Engineering Evaluation/Cost Analysis Non-Time Critical Removal Action Tank Farm IR-6

Naval Station Treasure Island
Hunters Point Annex
San Francisco, California
November 13, 1995

Response to Agency Comments of the Draft Engineering Evaluation & Cost Analysis Report for Removal Action at the IR-16 Tank Farm

RESPONSE TO AGENCY COMMENTS ON THE DRAFT ENGINEERING EVALUATION AND COST ANALYSIS REPORT FOR A REMOVAL ACTION AT THE IR-6 TANK FARM

Figure 2-2
Site Plan
Tank Farm IR-6
Hunters Point Annex

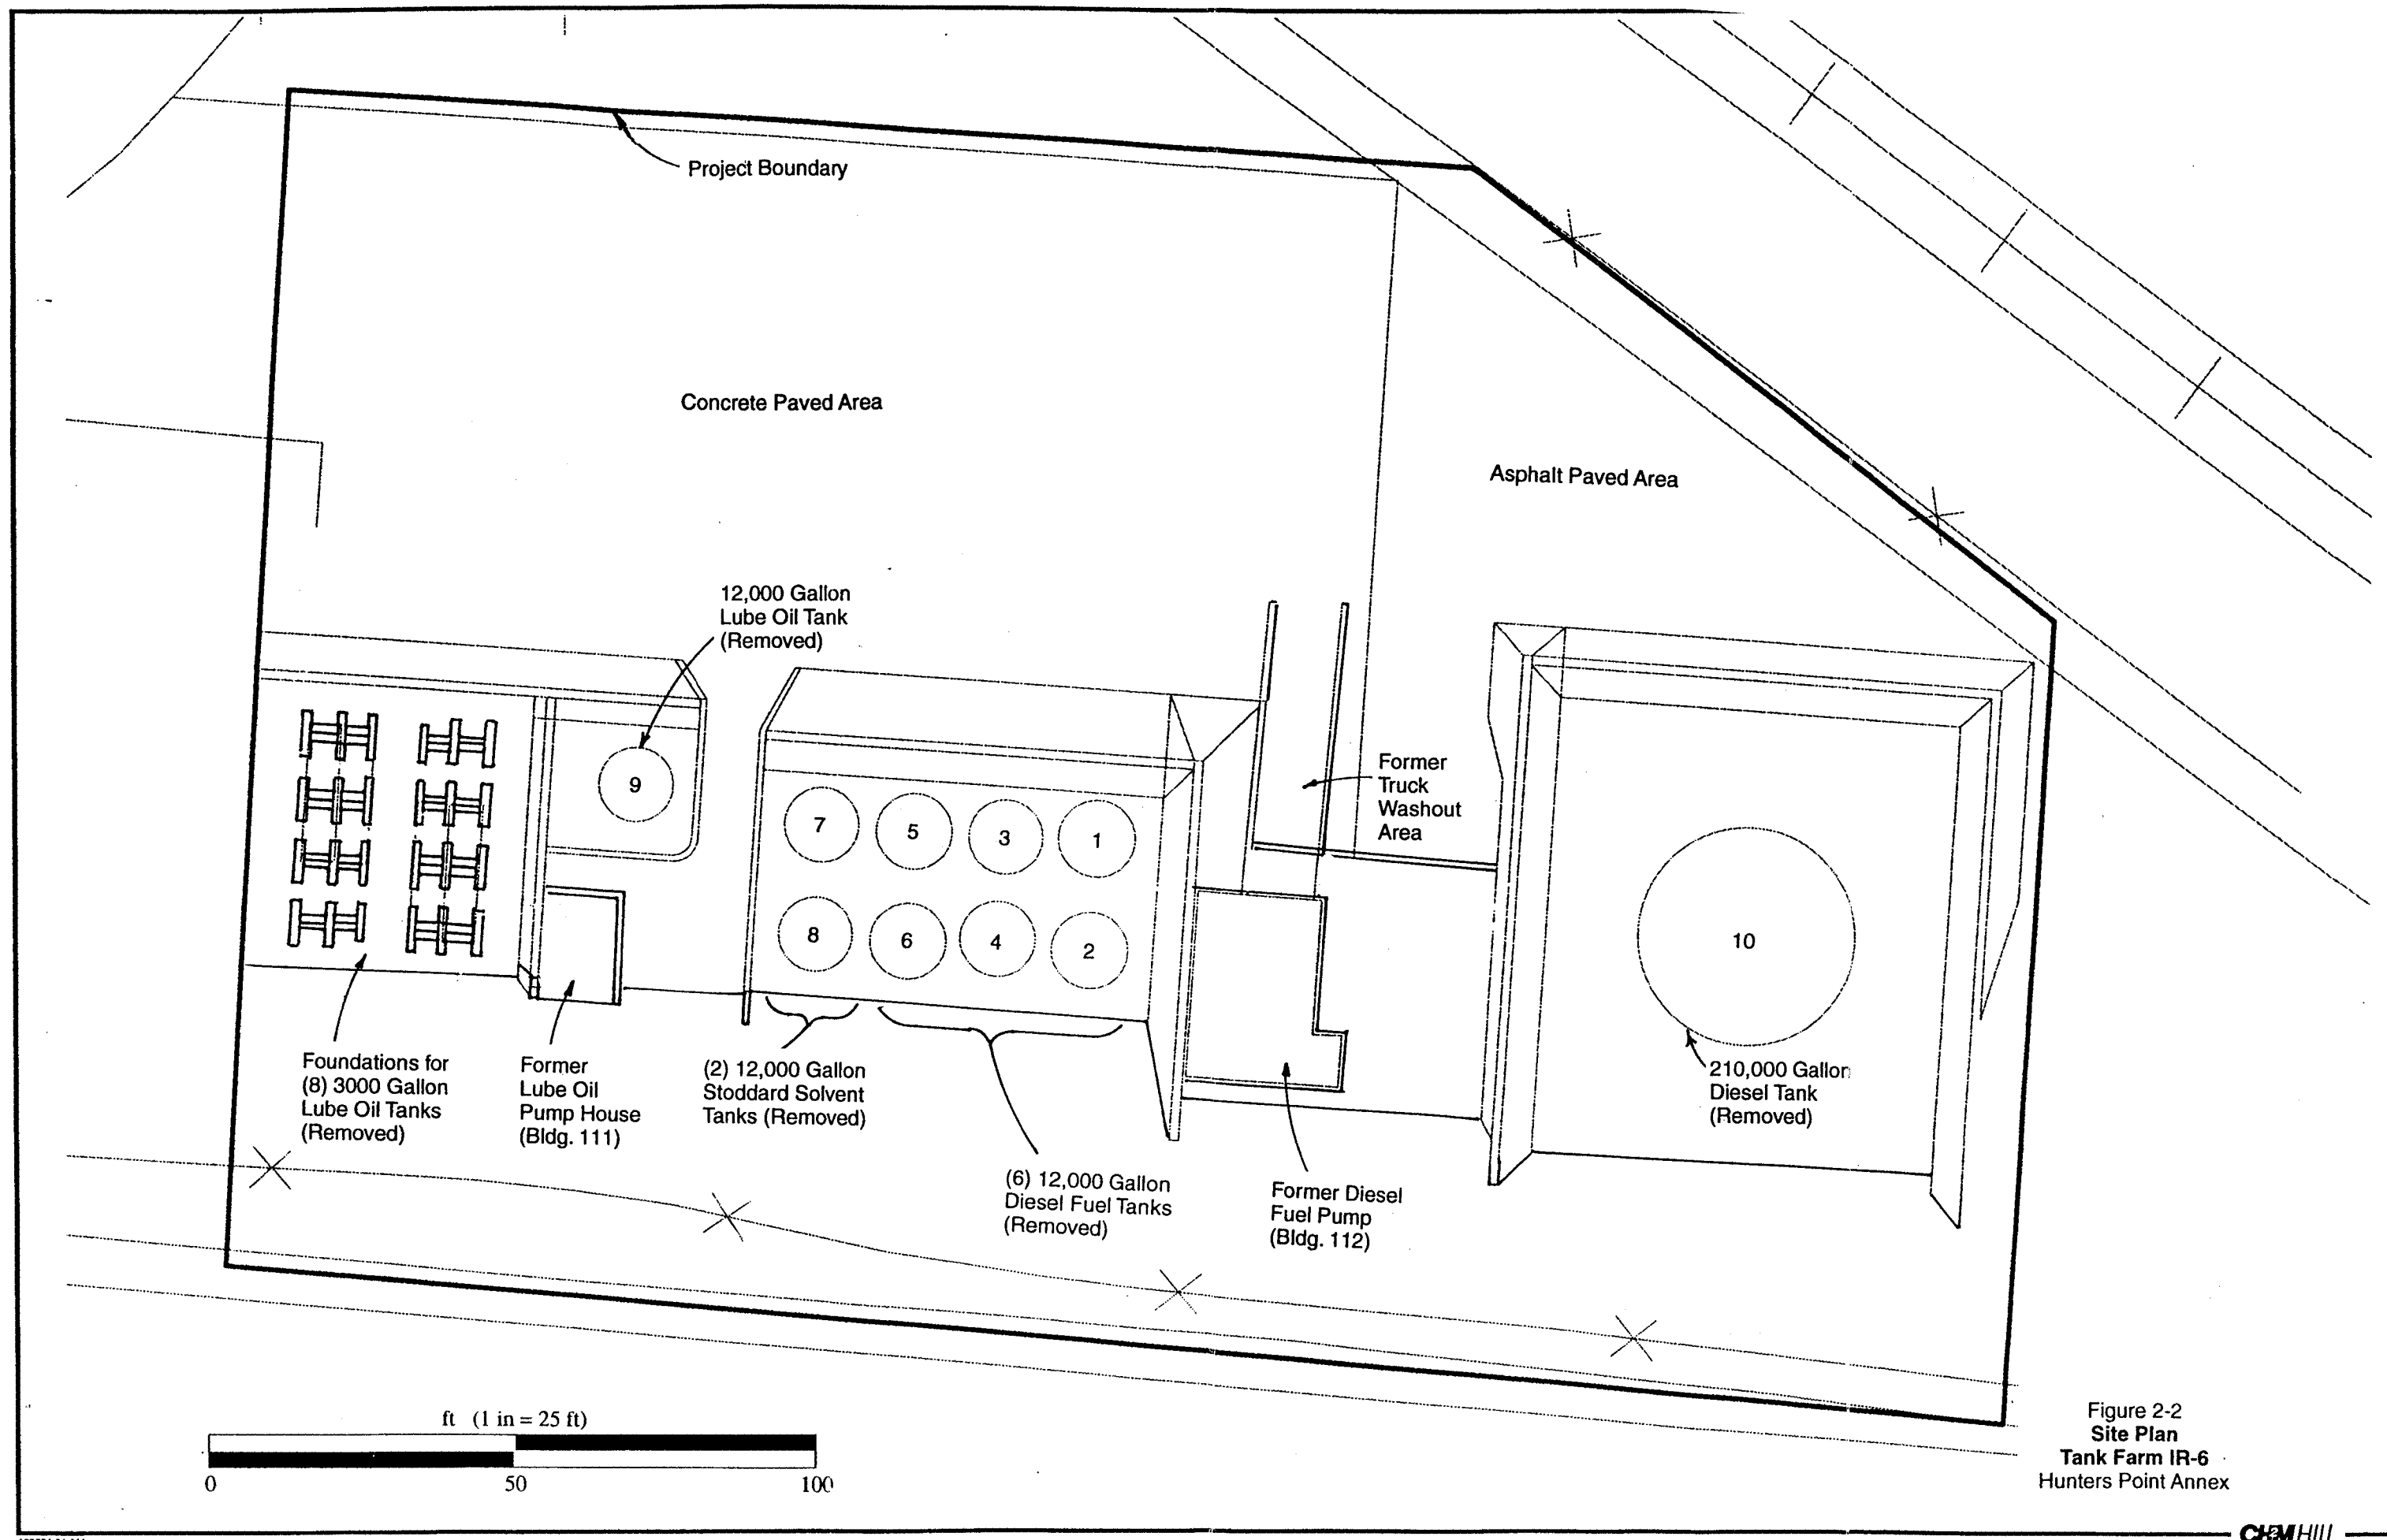
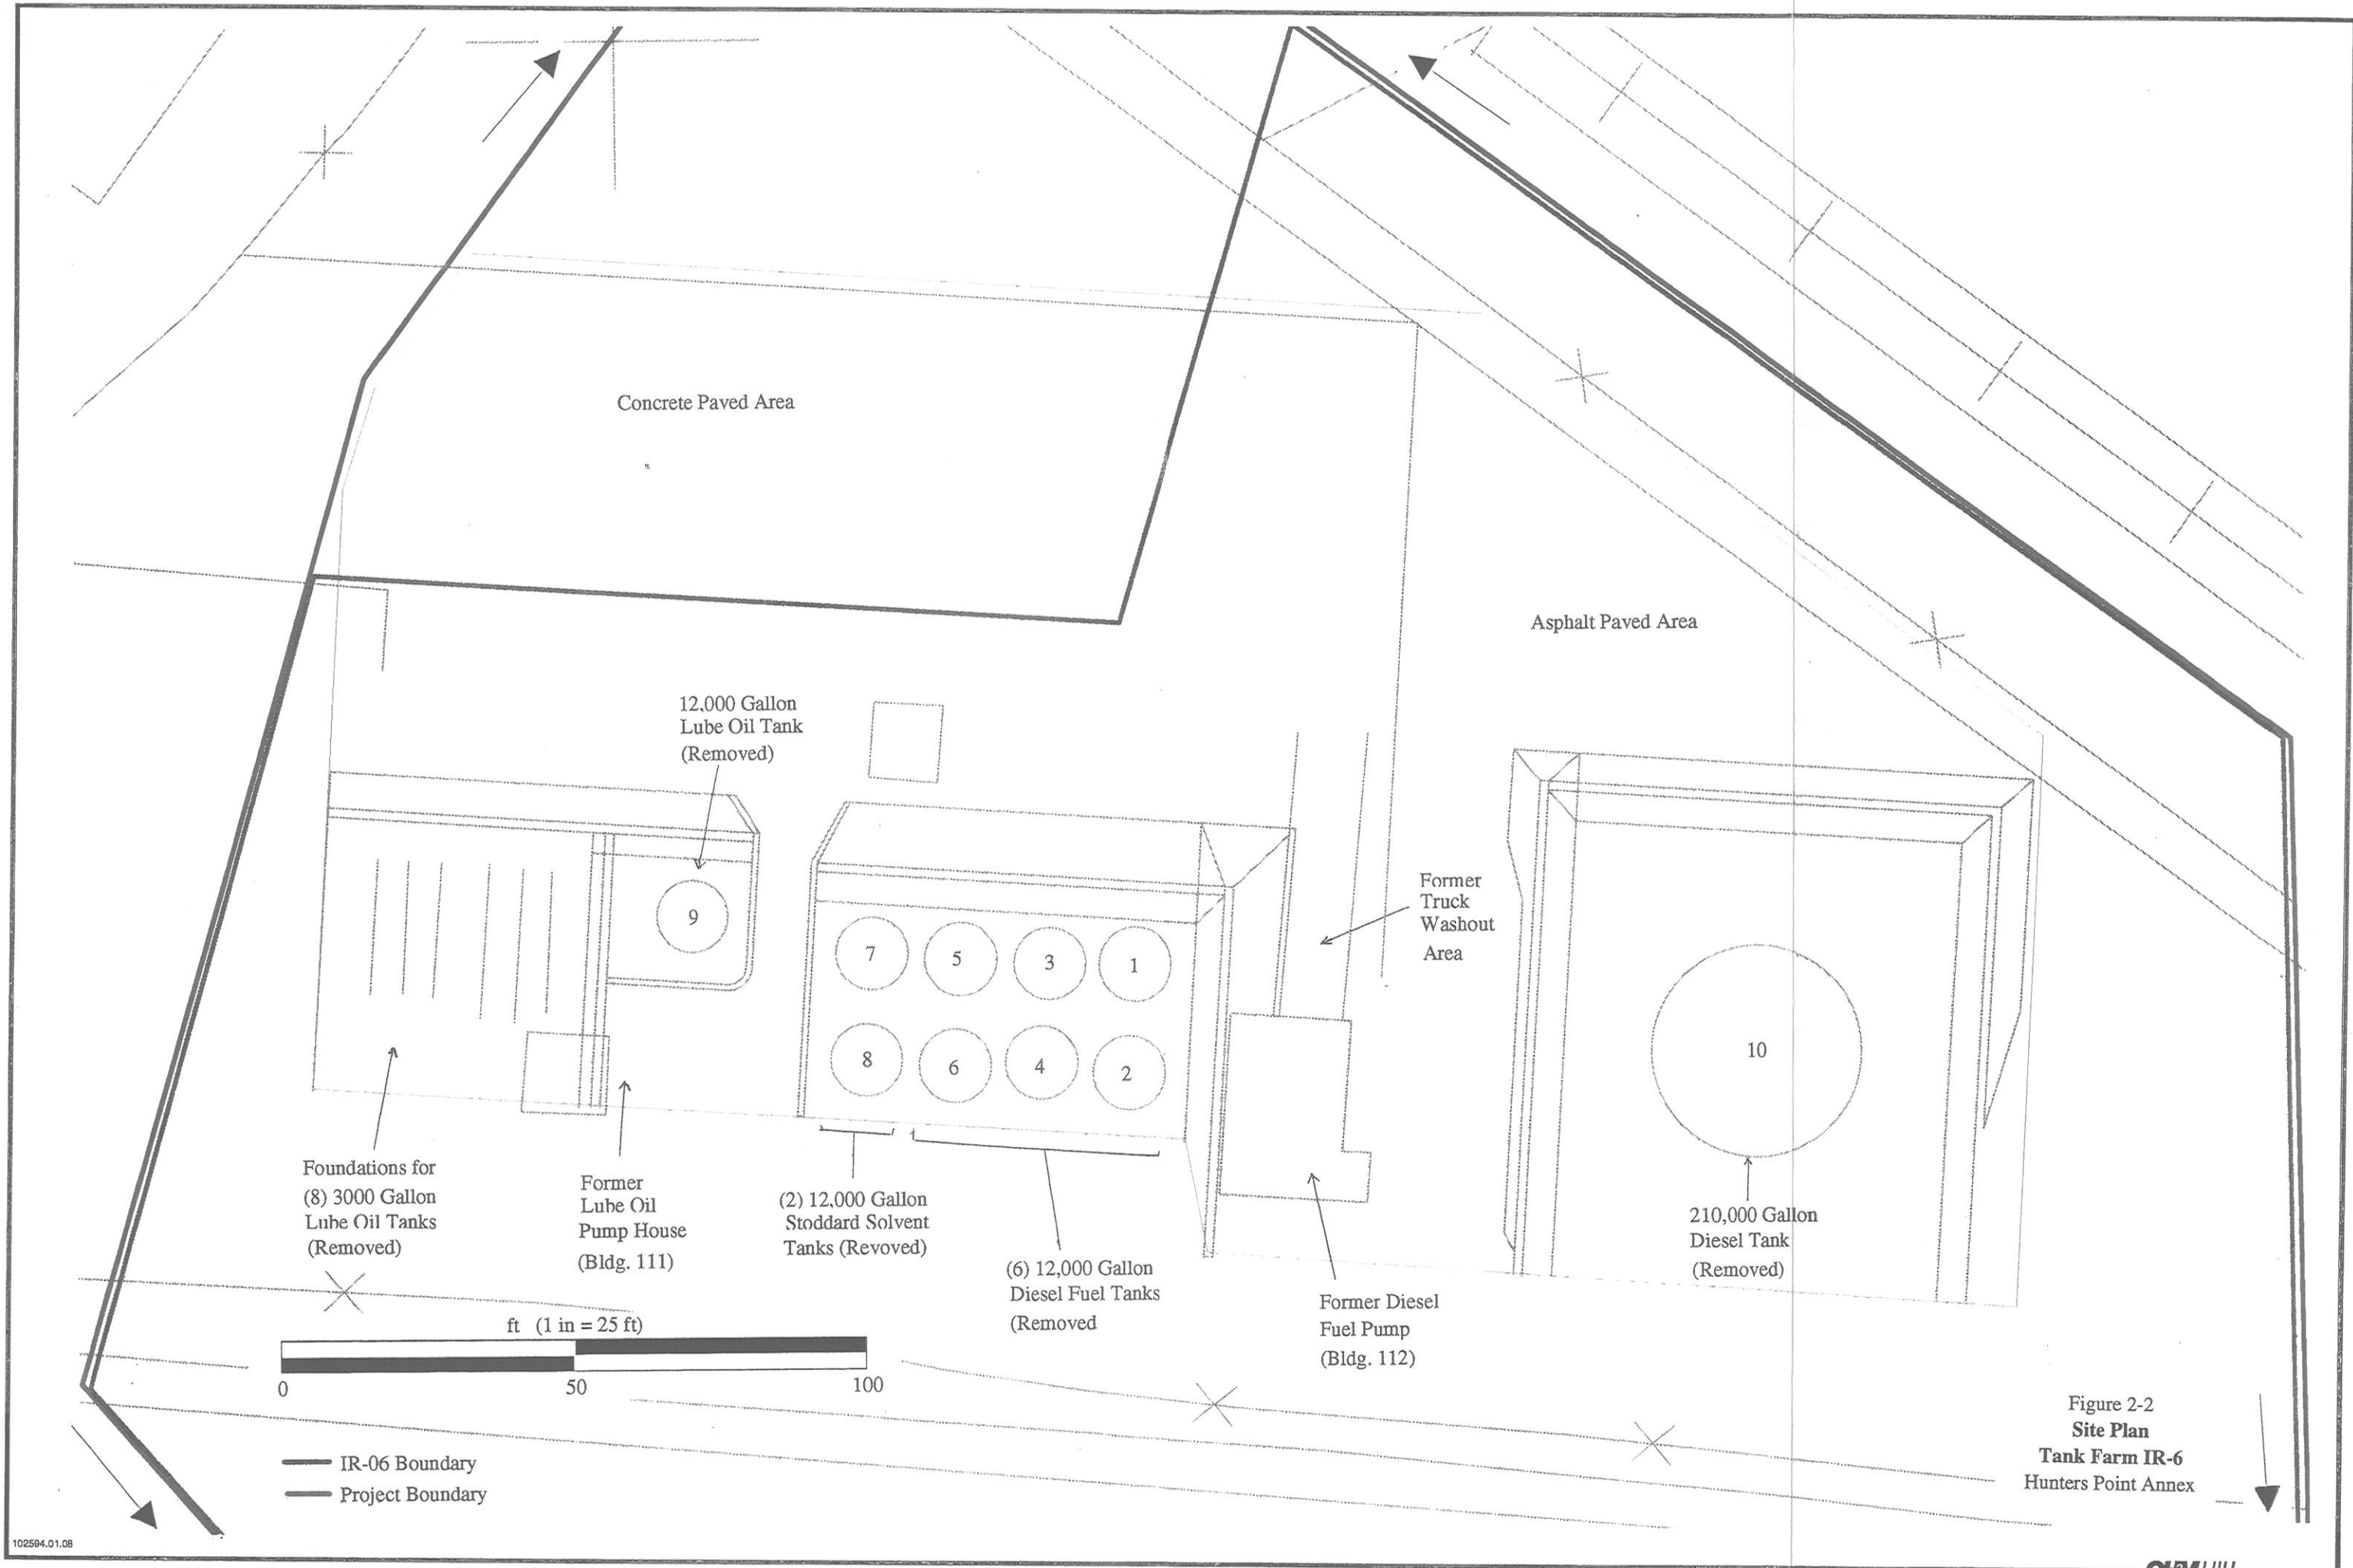
11. Provide reason(s) for the proposed project boundary of the removal action. For example....

20. *Figure 2-2, it is important to identify the boundary of the "project". It is not clear...*

The boundaries of the project have been redrawn to include all areas currently assigned to IR-6 as per the Risk Assessment produced by PRC. We have also included additional areas which were not included in IR-06 or other adjacent IR sites within our project boundaries. Please refer to the updated project and IR-06 boundaries presented in the attached Figure 2-2.

Please refer to the response for Specific Comment Number 11.

Figure 2-4
CH2M HILL Confirmation Sample Locations
Tank Farm IR-6
Hunters Point Annex

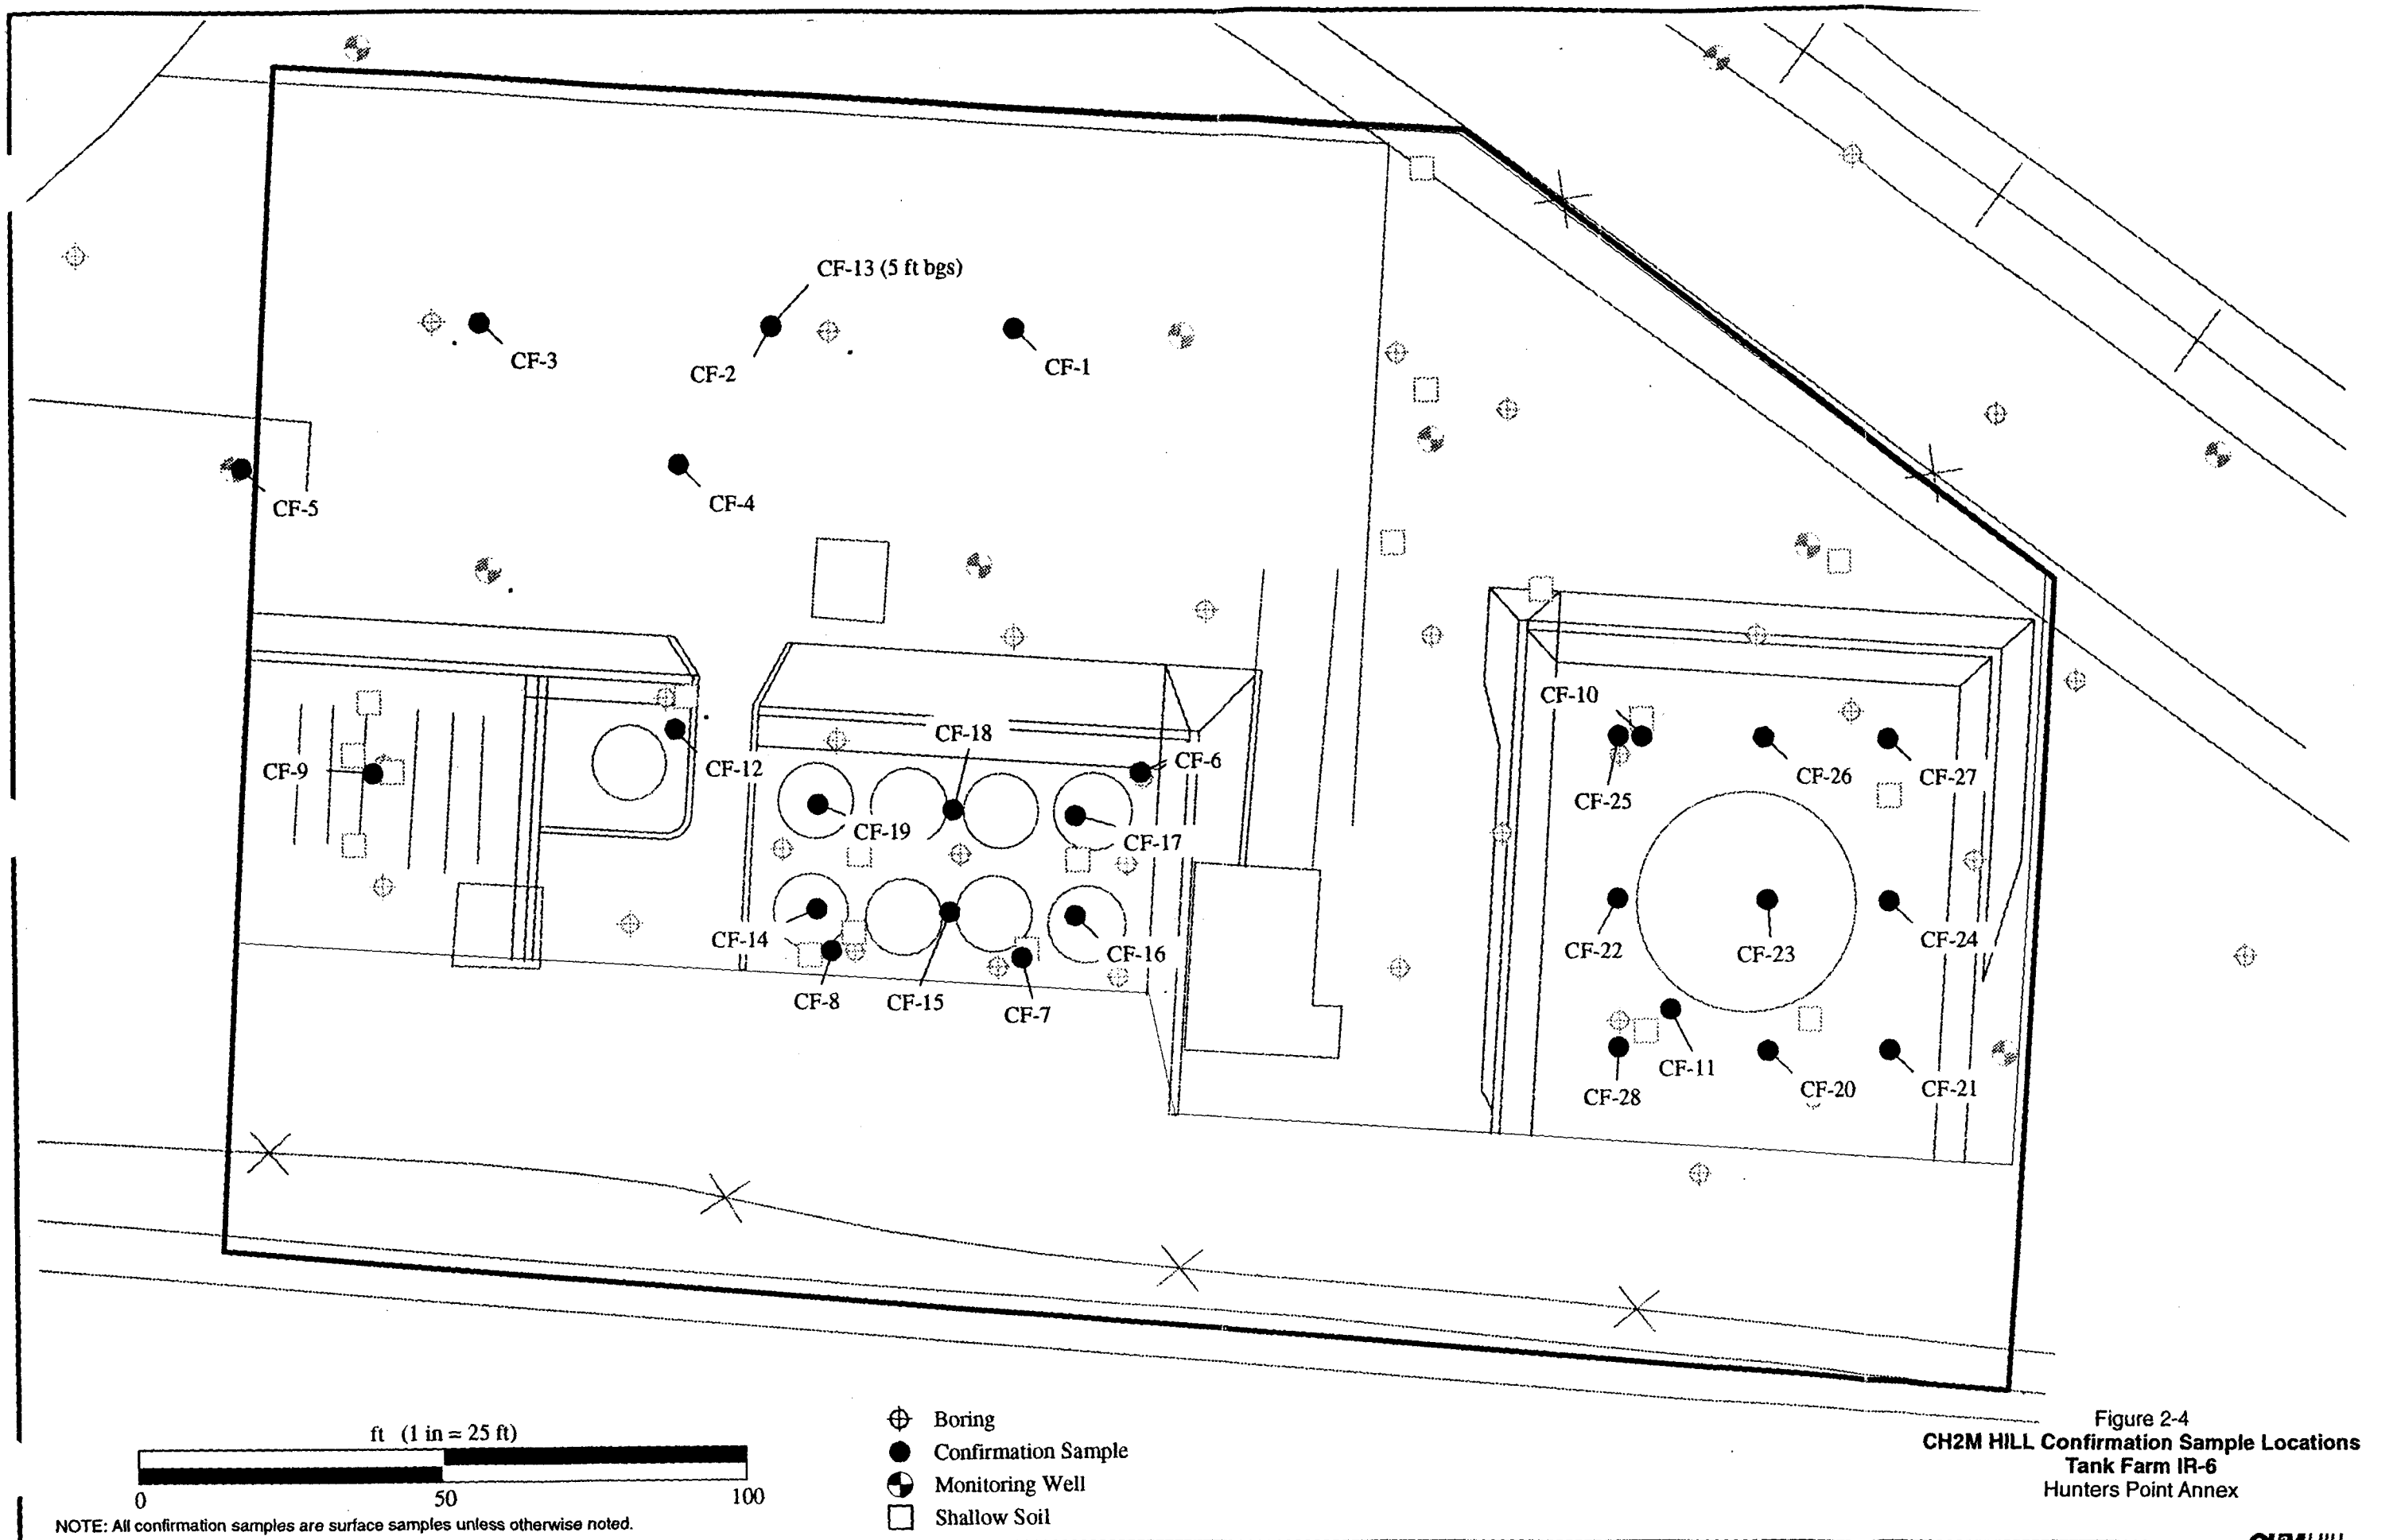
4. *Figure 2-4. This figure does not show the location of sample CF-13. This sample was taken to confirm PCB contamination and should be included on the figure.*

The figure does show the location of CF-13. It was collected in the same area as CF-2, but at a depth of 5 feet below ground surface.
